**COMMENTS OF HONDA MOTOR CO., LTD.  
REGARDING CARB MAIL-OUT #94-35  
"UTILITY AND LAWN AND GARDEN EQUIPMENT ENGINES  
PROPOSED AMENDMENTS"**

# HONDA G100K1

(ATTACHMENT TO HONDA COMMENTS ON CARB MAILOUT #94-35)

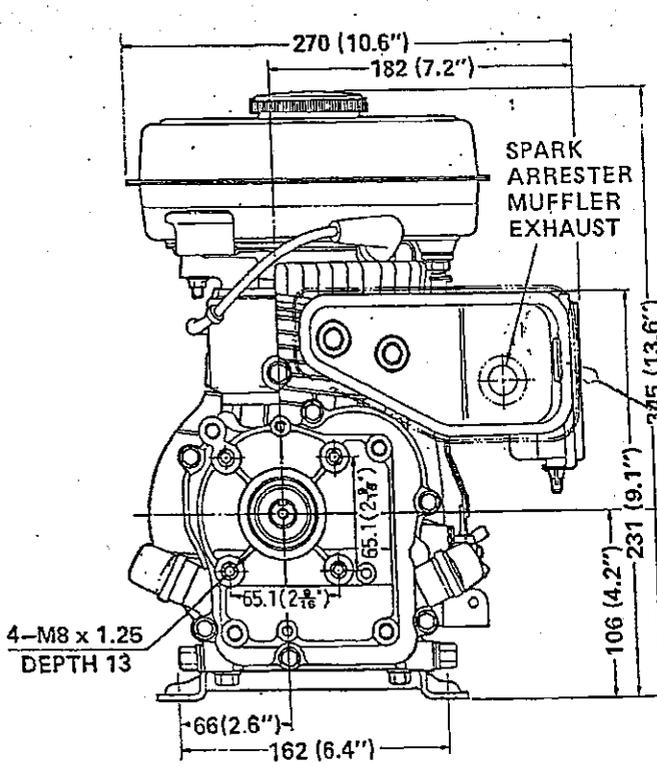
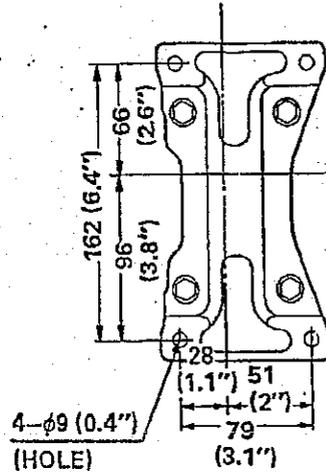
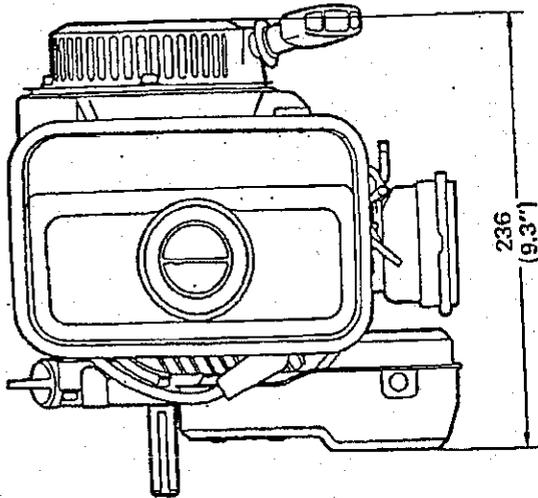
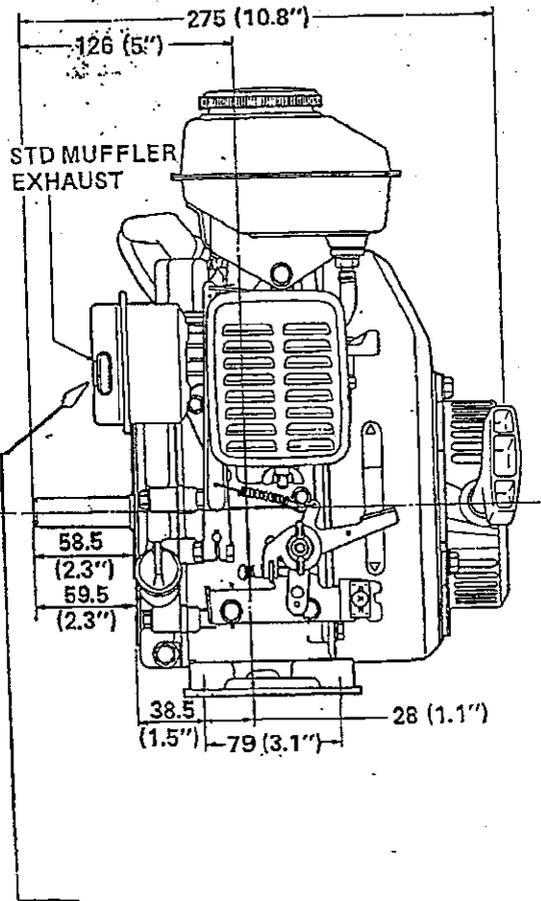
1. Basically, the exhaust gas regulations are intended to control the exhaust gas emitted from the engines, equipment or vehicles,
2. The exhaust gases in the muffler are not necessarily equivalent to the gases actually emitted from an engine's tail pipe,
3. We must avoid ingesting air from the atmosphere due to pressure pulsation in the exhaust,
4. Some small ULG engines, such as the Honda G100K1, have no exhaust conduit and no tailpipe (see attached drawing),

5. It is difficult to locate the sampling probe directly in the muffler of small ULG engines because it is too small,
6. If we locate a sampling probe in such a small muffler, the air from the atmosphere may be ingested into the sampling probe due to pressure pulsations in the exhaust and due to the small muffler size,
7. If we choose to use the mixing chamber, we will have to prepare mixing chambers of various sizes for our products depending upon engine displacement, and
8. Almost all 2 stroke engines for string trimmers would have the same problems mentioned above as G100K1.

# HONDA G100K1

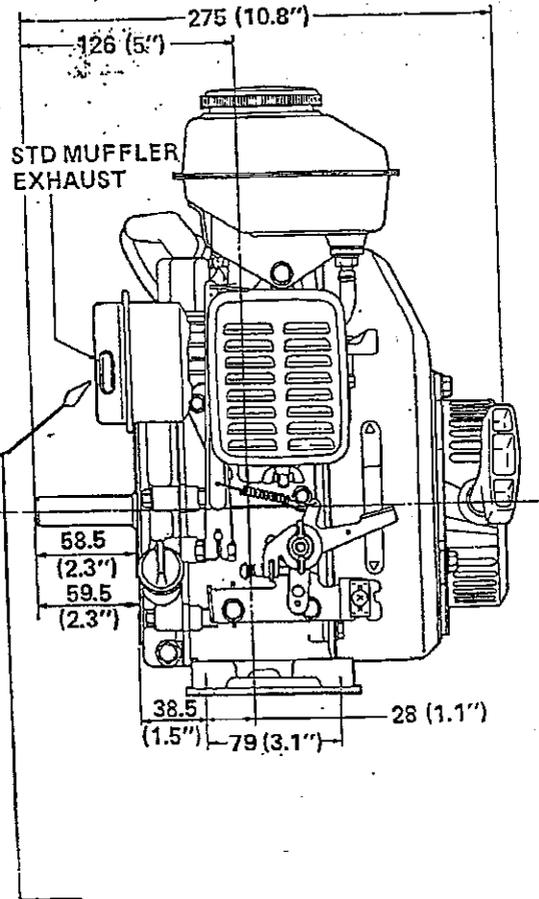
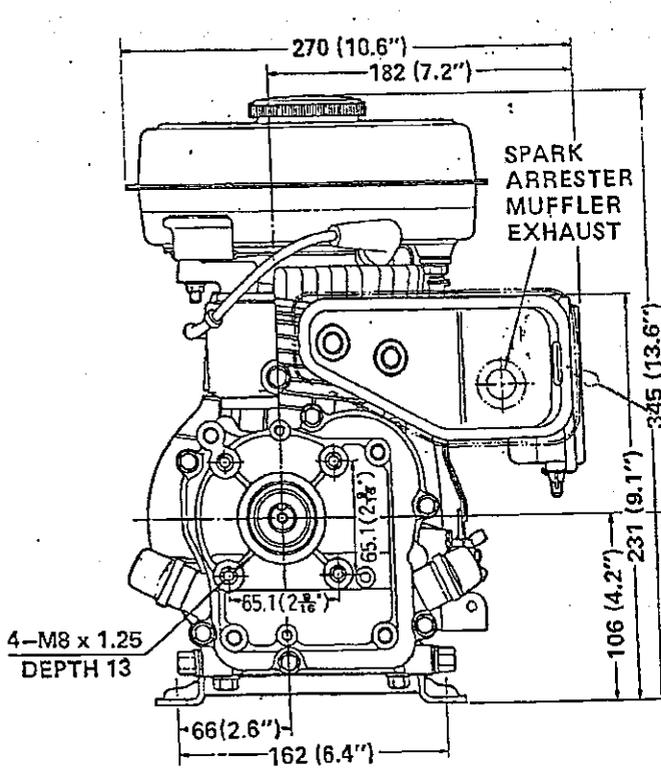
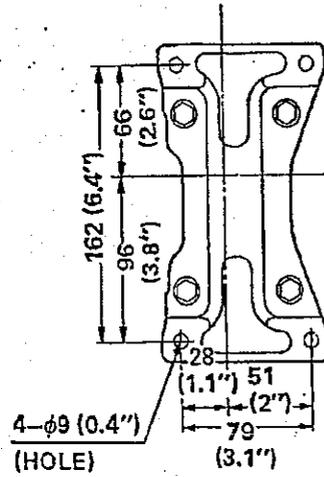
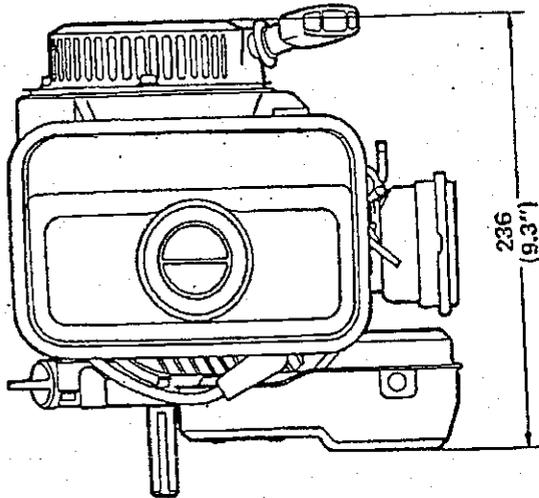
1. Basically, the exhaust gas regulations are intended to control the exhaust gas emitted from the engines, equipment or vehicles,
2. The exhaust gases in the muffler are not necessarily equivalent to the gases actually emitted from an engine's tail pipe,
3. We must avoid ingesting air from the atmosphere due to pressure pulsation in the exhaust,
4. Some small ULG engines, such as the Honda G100K1, have no exhaust conduit and no tailpipe (see attached drawing),

5. It is difficult to locate the sampling probe directly in the muffler of small ULG engines because it is too small,
6. If we locate a sampling probe in such a small muffler, the air from the atmosphere may be ingested into the sampling probe due to pressure pulsations in the exhaust and due to the small muffler size,
7. If we choose to use the mixing chamber, we will have to prepare mixing chambers of various sizes for our products depending upon engine displacement, and
8. Almost all 2 stroke engines for string trimmers would have the same problems mentioned above as G100K1.
